Access Compliance Report

Intersection ID: 45983	Main Street: MASON_MILL_PL	Cross Street: WOODBOURNE_LN	Location: NE
ADA ID: DC0B000B0F8C	Ramp Type: PerpDiag	Initial Pass/Fail: Fail	Overall Compliance: No
Severity Score: 21.25			
Codes/Mitigation Info/Possible Solution		Field Measurements/Component Compliance

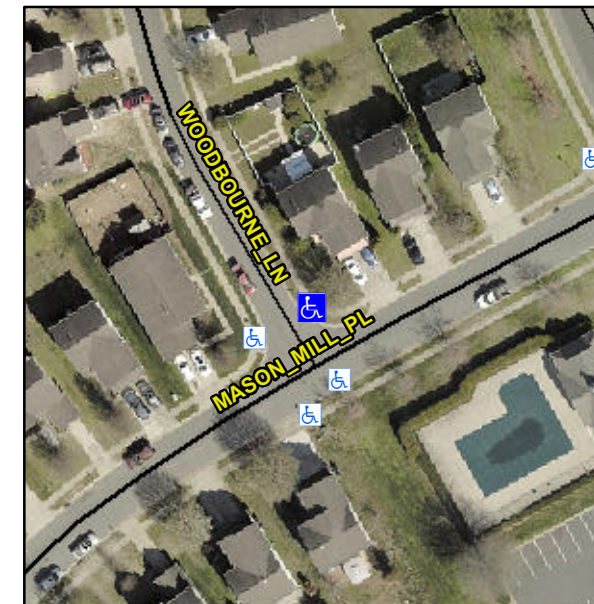
Compliance	Description	Data	Compliance	Description	Data
N/A	Ramp Length (in)	47.0	No	Ramp Slope (%)	8.8
No	Ramp Width (in)	39.5	Yes	Ramp XSlope (%)	0.3
N/A	Flare Type LT	N/A	N/A	Flare Type RT	N/A
N/A	Flare Slope LT (%)	N/A	N/A	Flare Slope RT (%)	N/A
N/A	Flare Traversable LT?	N/A	N/A	Flare Traversable RT?	N/A
N/A	Landing Length (in)	N/A	N/A	DWS Provided?	N/A
N/A	Landing Width (in)	N/A	N/A	DWS Contrast?	N/A
N/A	Landing Slope (%)	N/A	N/A	DWS Length (in)	N/A
N/A	Landing X Slope (%)	N/A	N/A	DWS Full Width?	N/A
N/A	Landing Curb? (Y/N)	N/A	N/A	DWS Offset (in)	N/A
N/A	Shared Landing?	N/A			
N/A	Gutter Ponding?	N/A	N/A	Gutter Slope (%)	N/A
N/A	Gutter Lip Ht (in)	N/A	N/A	Gutter X Slope (%)	N/A
N/A	Painted X Walk1?	No	N/A	Painted X Walk2?	No
	X Walk 1 Direction	To W		X Walk 2 Direction	To S
N/A	X Walk 1 Width (in)	N/A	N/A	X Walk 2 Width (in)	N/A
	X Walk 1 Slope (%)	2.3		X Walk 2 Slope (%)	2.2
	X Walk 1 X Slope (%)	0.0		X Walk 2 X Slope (%)	1.2

Remove & Replace Curb Ramp With Two New Directional Ramps or Equivalent.
